Updated Field Safety Notice

Philips MR systems with MR Elastography (MRE)
Potential for inaccurate (lower) liver stiffness measurements

May 2026

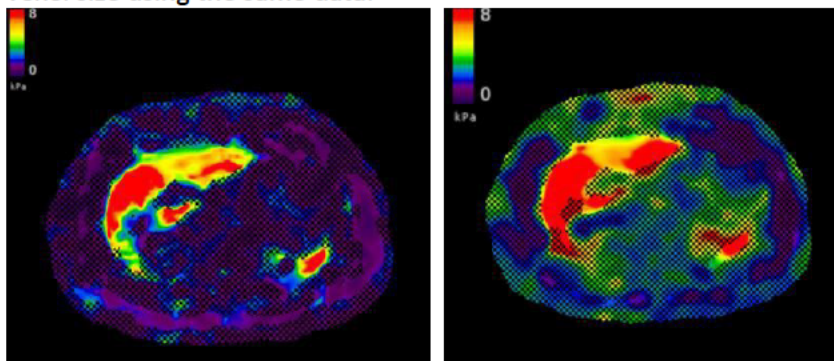
Philips has become aware through the MRE software system developer Resoundant about an issue affecting MRE stiffness measurements when a specific range of image reconstruction parameters is used in combination with Resoundant’s algorithm. Specifically, the reconstruction voxel size settings in the default MRE scan protocol are too small, which can potentially lead to inaccurate liver stiffness measurements (lower values). See Figure 1.

Figure 4. Updated MRE protocol settings in the Geometry tab

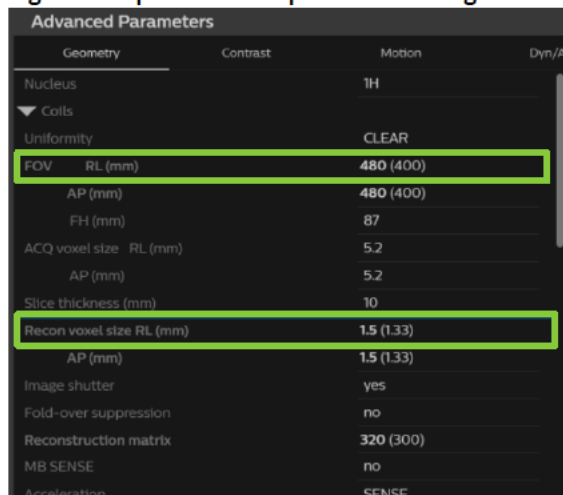
4. On the Geometry tab make the following changes
 - Change the FOV RL to 480 mm
 - Change the Recon voxel size RL to 1.5mm
 - Accept the changes
 - NOTE: For the FFE_MRE_4sl protocol on Release 12 systems, it may be necessary to re-enter the Recon voxel size RL of 1.5mm if the system defaults to 1.48mm.
